Neoteric Hovortrek Deluxe with reverse system

Instrumentation Panel and Control Details for 4 Passenger

SIG.	NO.	REVISION	DATE
 Neoteric Hovercraft Inc. 1649 TIPPECANOE STREET TERRE HAUTE, INDIANA, U.S.A. 47807-2394 TELEPHONE (812) 234-1120 FAX (812) 234-3217			
DRAWN:	CJ POEHLEIN	NAME:	HOVERTREK SENDERS
DATE:	9 JUN, 2015	NUMBER:	16647
		REV.	2

NEW COOLANT TEMP PROBE & COMP. FITTING
20 FEB, 2018.

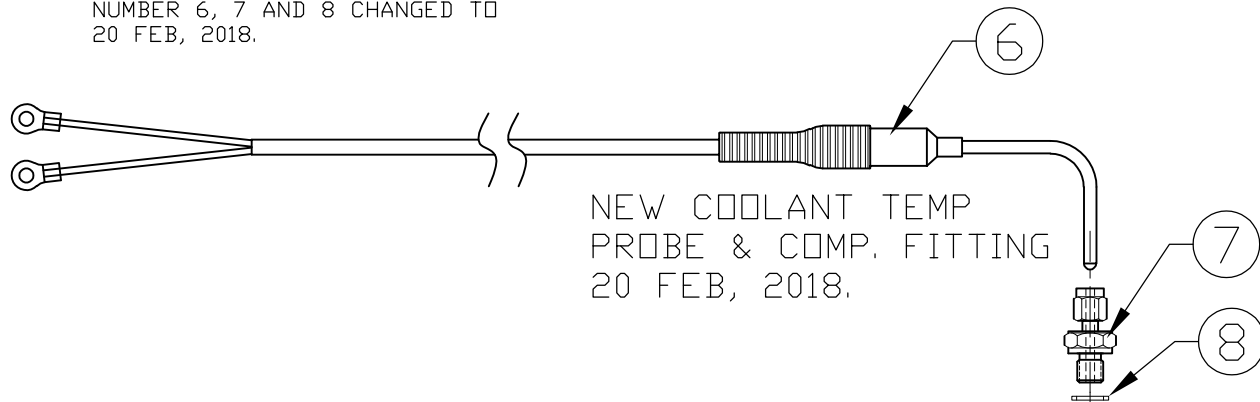
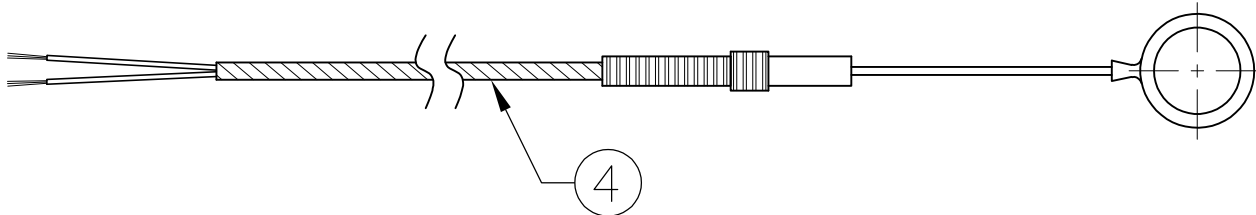
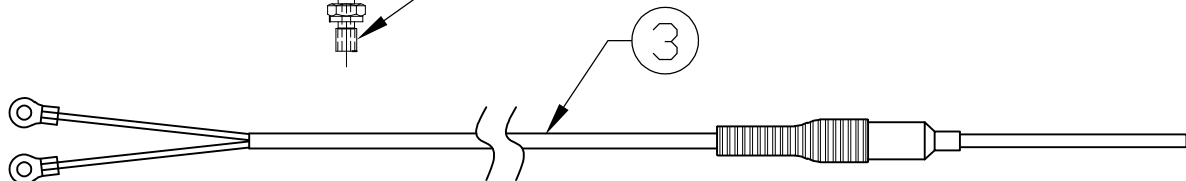
- 1) EGT COMPRESSION FITTING COMES WITH EGT PROBE WHEN PURCHASED.
- 2) CAN ORDER JUST COMPRESSION FITTING IF NEEDED.
- 3) NEW COOLANT TEMP. COMPRESSION FITTING COMES WITH PROBE WHEN PURCHASED.
- 4) NEW COOLANT TEMP PROBES NUMBER 6, 7 AND 8 CHANGED TO 20 FEB, 2018.

OLD WATER TEMP SENDER

M8 X 1.00 THREAD
